SUBJECT: RECALL R16YL
VISION STARTER CABLE ROUTING W/CAT C707 ENGINES

NHTSA Recall Number: 16V-100 School Bus
NHTSA Recall Number: 16V-101 Non-School Bus

Subject: RECALL R16YL, Vision Starter Cable Routing W/CAT C707 Engines

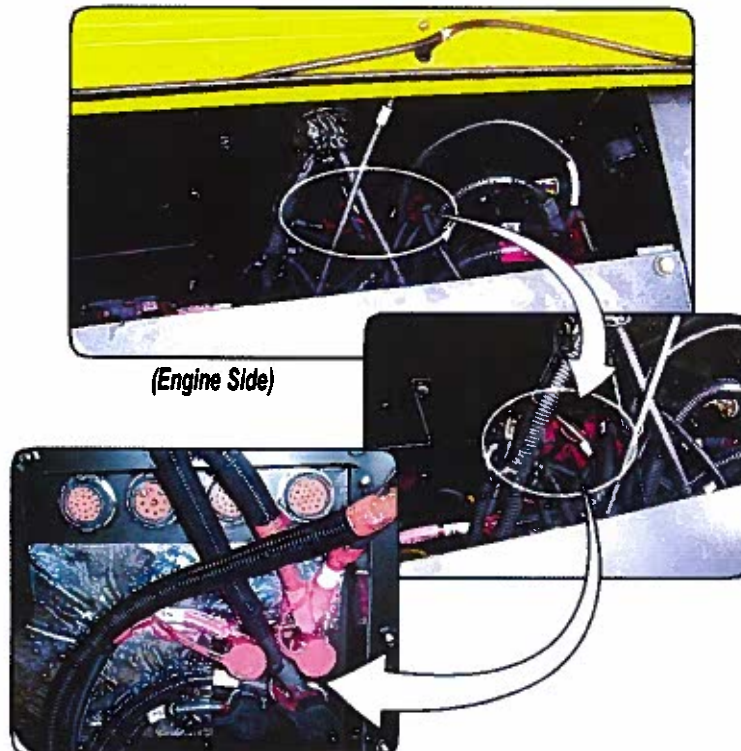
Starter cable may have been installed on the incorrect power stud which could cause the 4 gauge cable to be compromised during cranking process.

If starter cable is installed incorrectly, relocate starter cable from Electrical Power Stud to Chassis Power Stud. Inspect 4 gauge battery cable from Electrical Power Stud to battery for any damage and replace any damaged cable.

INCORRECT ROUTING

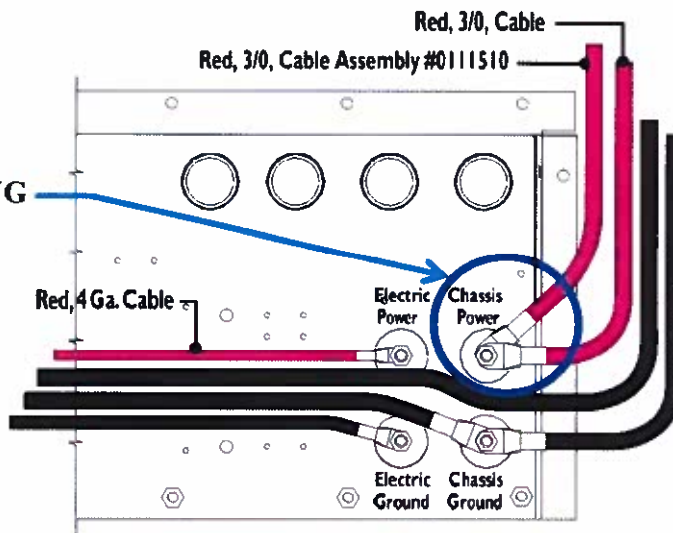
- 4. The lower end of Cable Assembly 0111510 should be attached to the Chassis Power Stud. If the cable is in this location, no further action required. If the lower cable end is attached to the Electrical Power Stud, remove it and attach it to the Chassis Power Stud. (See figures below)
- 5. Tighten both stud nuts to 11-15 ft.lbs. and apply a corrosion protection such as red glyptal.
